Hi-Fi Products
Service Bulletin

Model: TA-DL100

No. 191

Subject: Incorrect Labeling of IC203/IC204 **Date:** May 8, 1991

[DECODER BOARD]

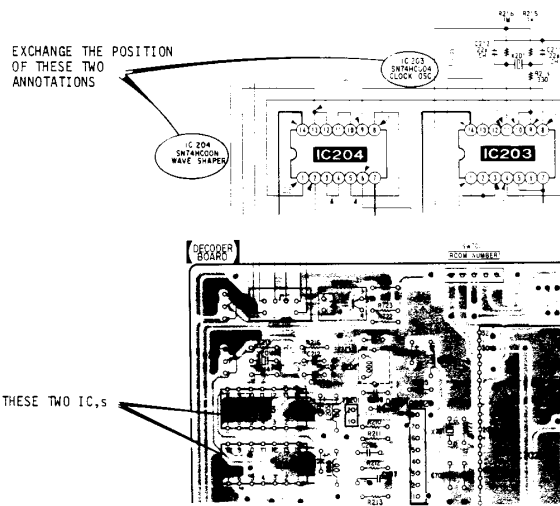
The service manual (schematic diagram, physical diagram, and parts listing) has IC203 of the Decoder board listed as the clock oscillator (SN74HCU04) and IC204 as the wave shaper (SN74H00N).

Solution: Change the schematic, physical diagrams, and the parts list to show IC203 as the wave shaper and IC204 as the Clock Oscillator.
